Report No. DODIG-2012-132 September 14, 2012

Project Planning Resulted in Outstanding Building Deficiencies and Decreased Functionality of the Main Fire Station at Naval Station Great Lakes

SUBJECT: Project Planning Resulted in Outstanding Building Deficiencies and Decreased
Functionality of the Main Fire Station at Naval Station Great Lakes
(Report No. DODIG-2012-132)

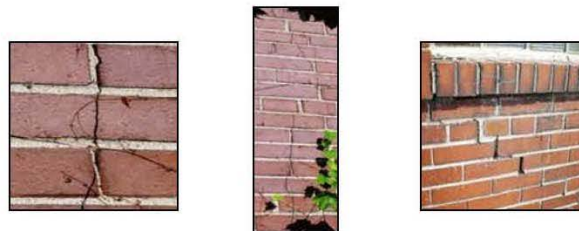
As of 26 August 2011, the audit team observed that scuppers (which provide secondary drainage) are much higher than primary drain covers on the East area of the roof (left). During heavy rain, this design may not ensure adequate drainage. The audit team also observed bare spots and broken and failed gravel stops (right). These problems may cause water ponding on the East roof.

- The Phase II Technical Proposal, Factor 2, Exterior Architectural Elements requires the contractor to inspect and repair the existing roof to ensure it is weather tight and serviceable. Cracks, alligatoring, bare spots, blistering, rupturing, curling low spots and water ponding will be repaired. Any broken, failed or missing gravel stops will be repaired as well.
